Product Change Notification - ASER-18GLCT091

CCB 4193 Final Notice: Qualification of MTAI as a new final test site for selected SST25VF016B-50xxx products available in 8L SOIJ (5.4x5.4x2.16mm) package.

CCB 4193

MTHAI

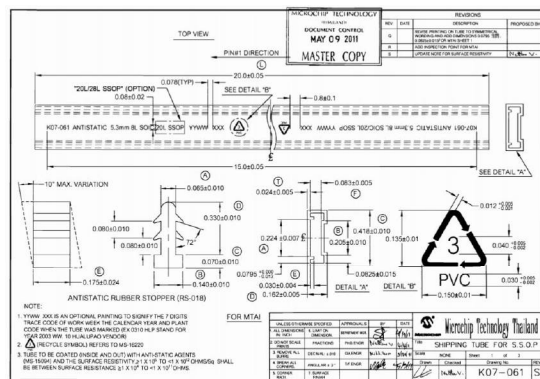
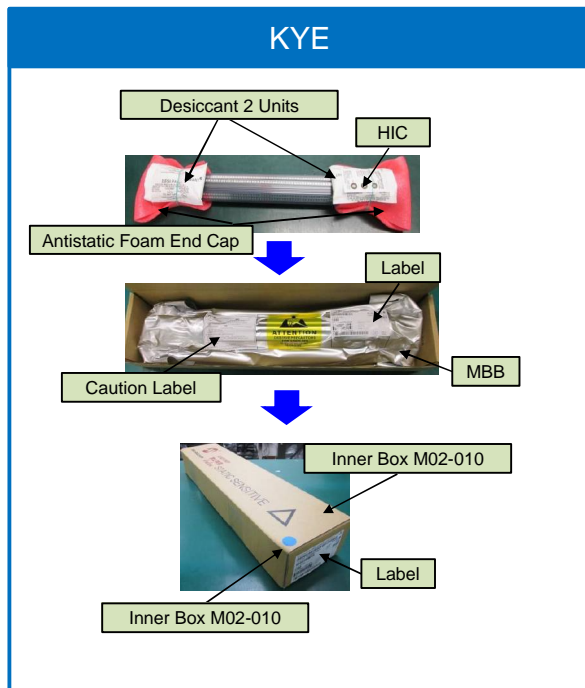
Tube Length	Dimension	Color
20.00 +/-0.05 inch	See on drawing	Clear

MTHAI

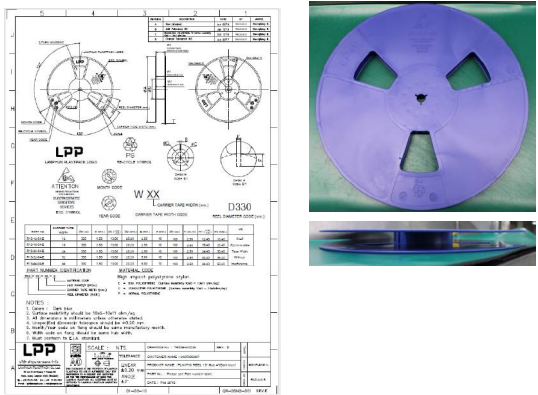
Width	Supplier	Diameter	Supplier Part	Hub	Color
16mm	Advantek	330mm +/- 2.0mm	R13-16-04-E	4inch (102 +/- 0.2mm)	Dark Blue

Width	Supplier	Diameter	Supplier Part	Hub	Color
16mm	LPP	330mm +/- 2.0mm	R13-16-04-E	4inch (100mm +/- 0.2mm)	Dark Blue
